SITE SUPPLEMENTAL INSTRUCTION

PROJECT: Forestside Estates
Attmar & Palleschi Drive
Brampton, Ontario

SITE SI NO. E-6

PURPOSE: Revised as per Arch SI A01 and Mech S SI M-2.

TITLE
SINGLE LINE DIAGRAM
ELECTRICAL

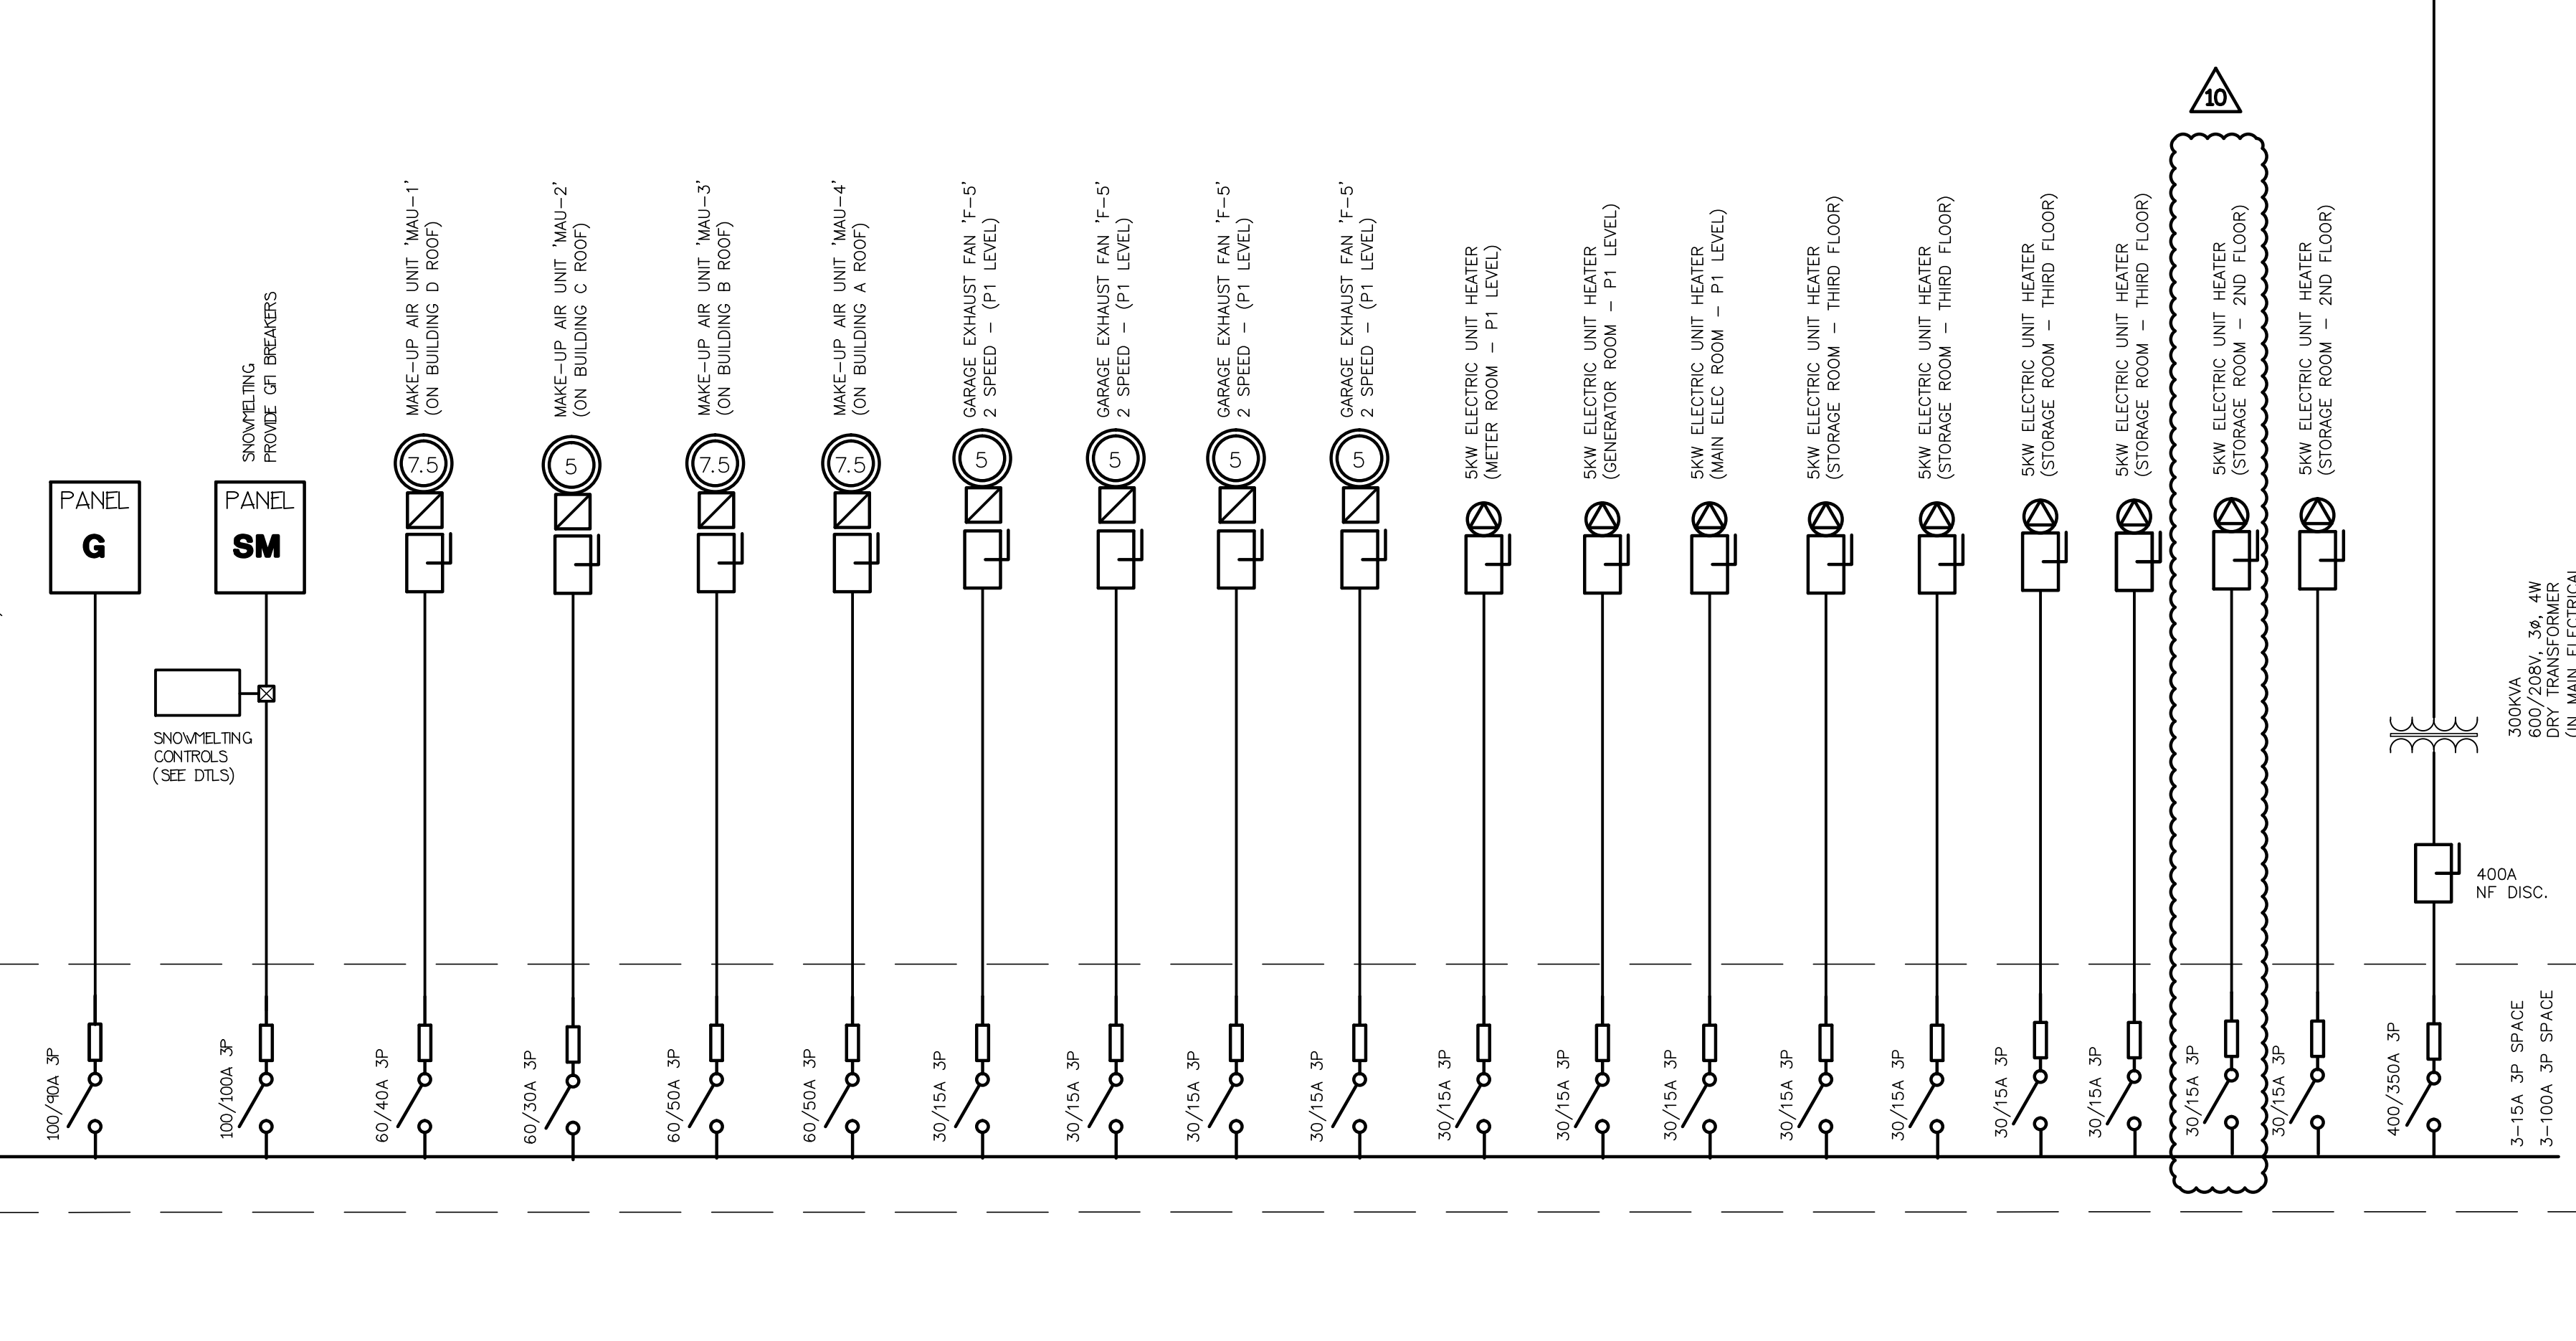
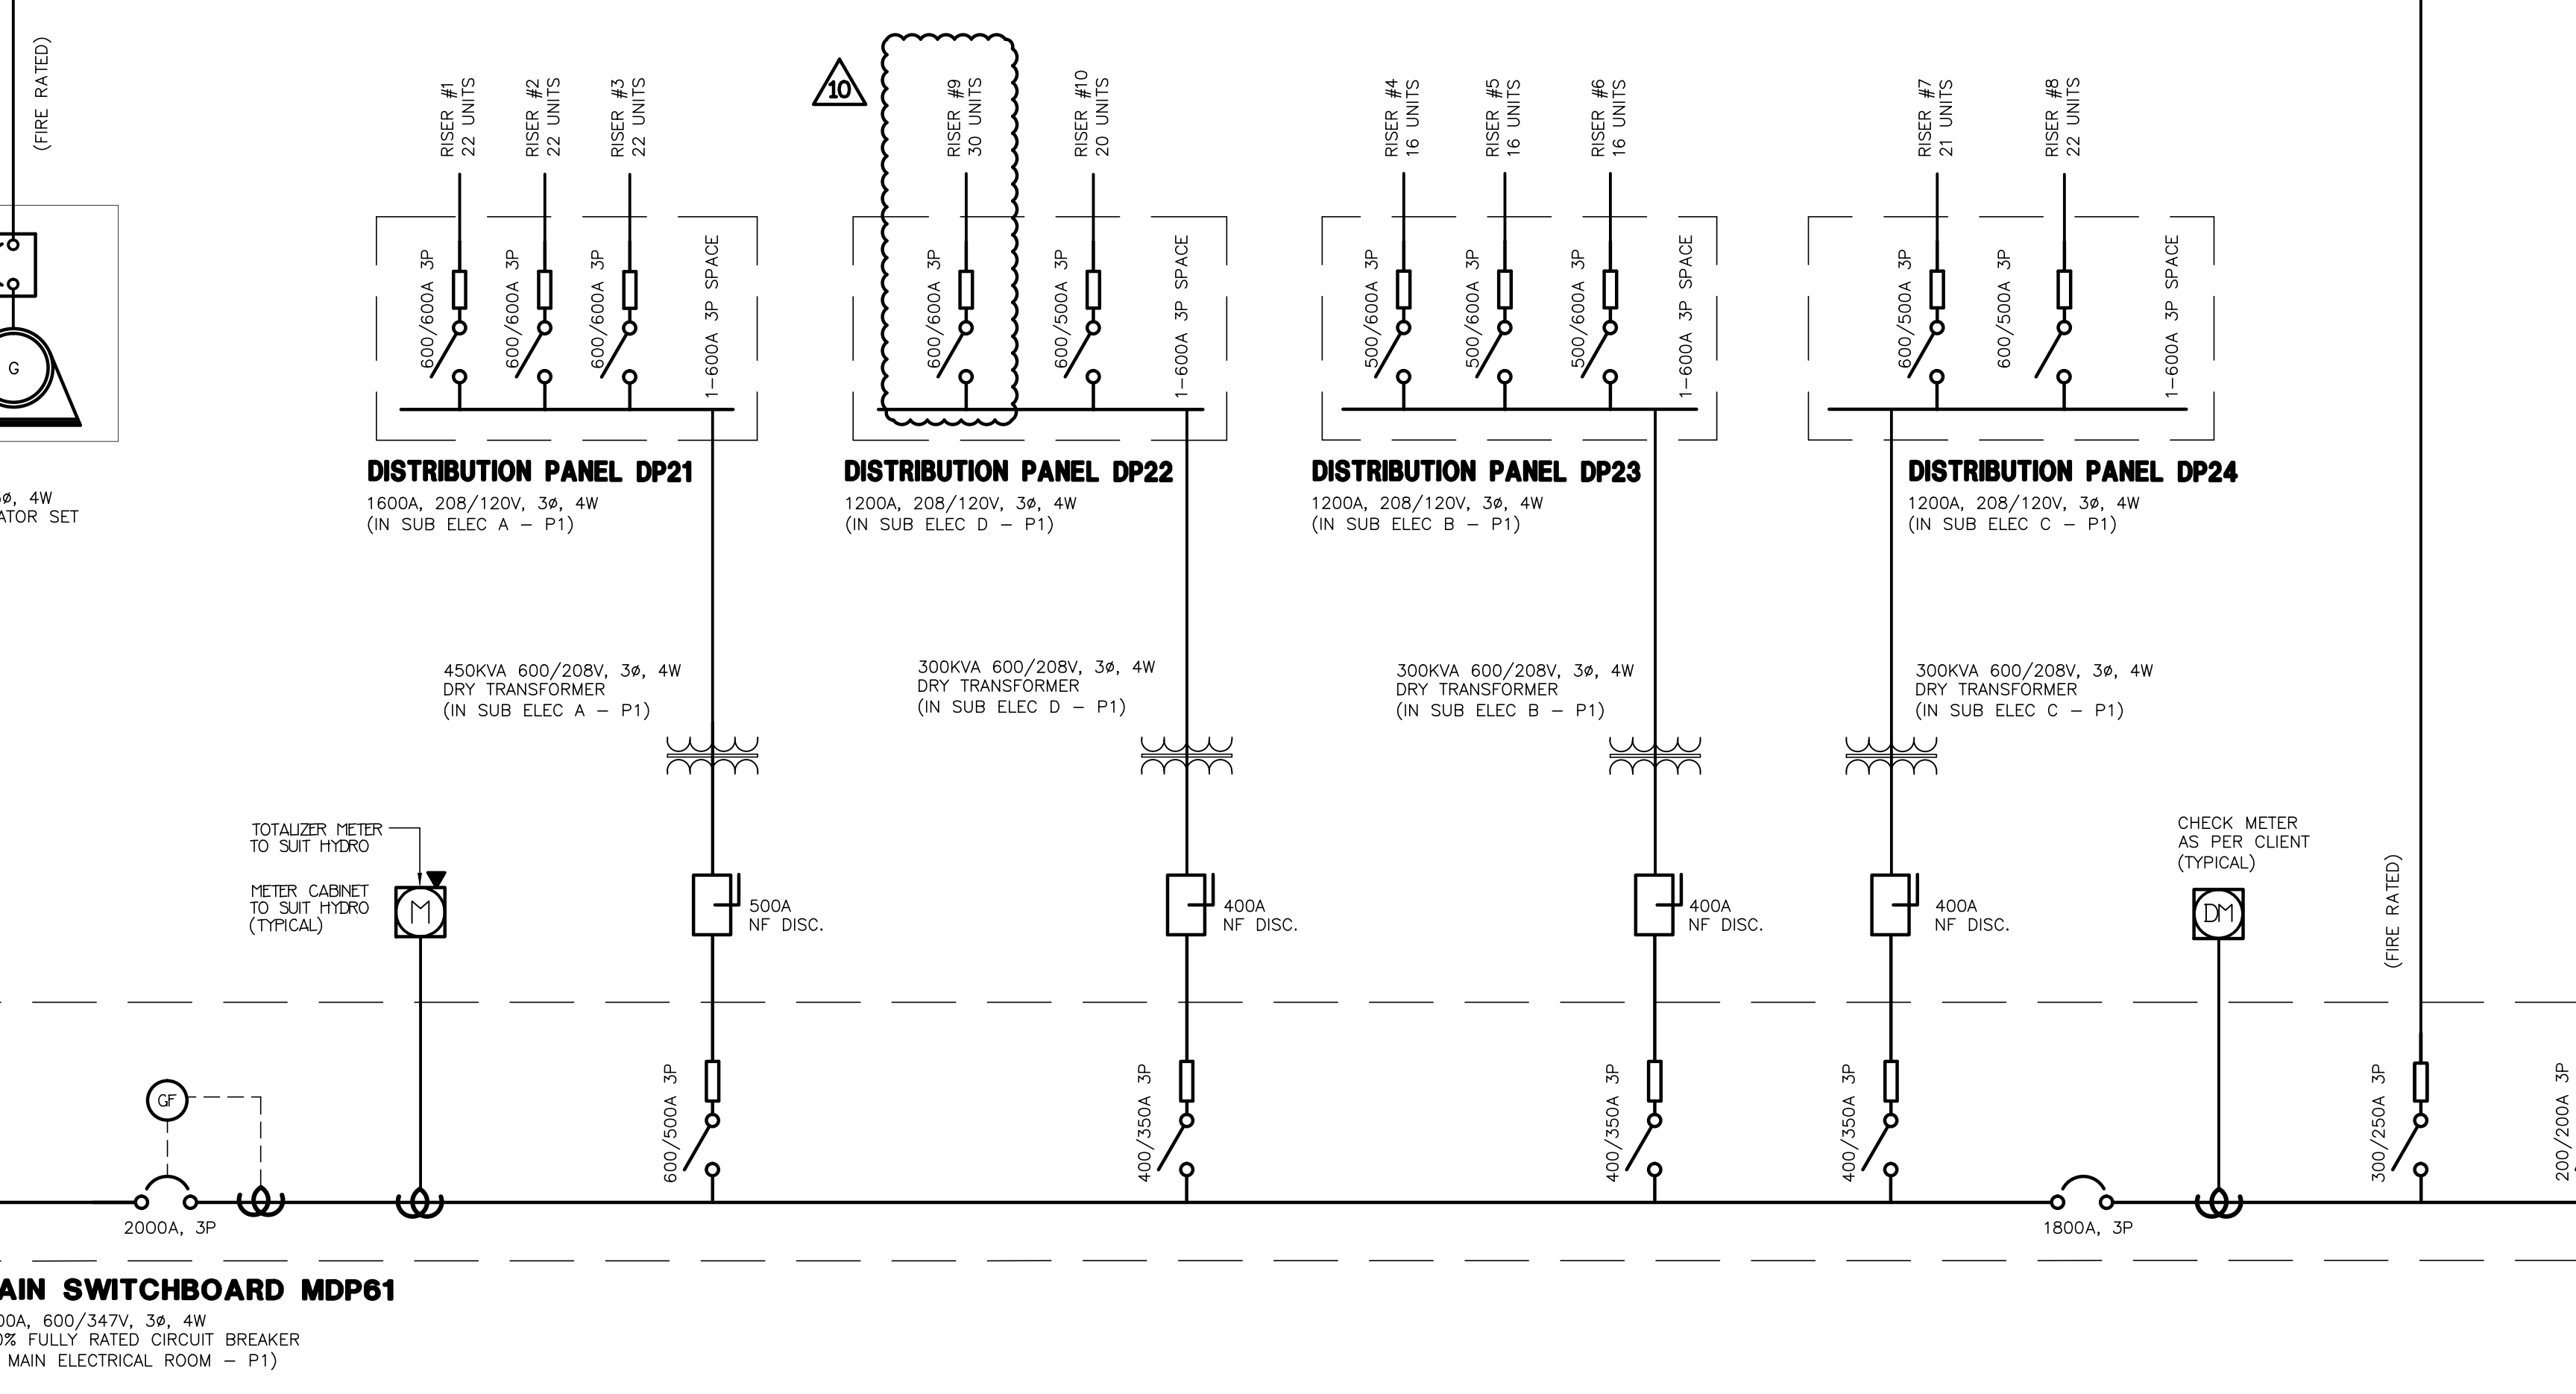
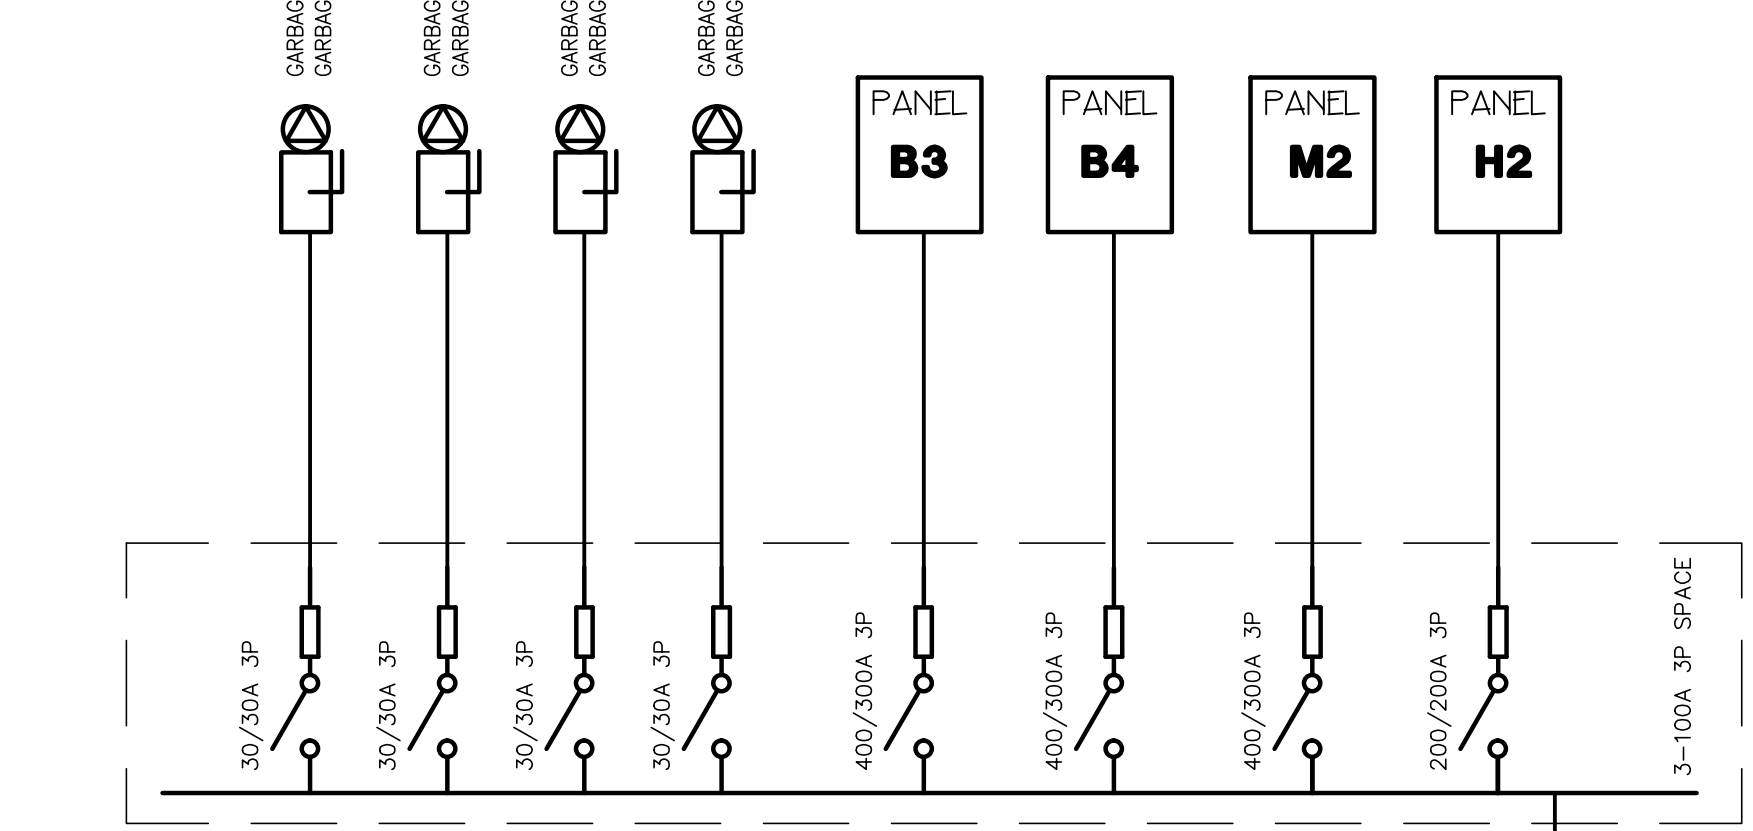
6.0 Reference Drawings E-12 (Single Line Diagram - Electrical) Issued

6.1 Revise: Single line diagram as shown.
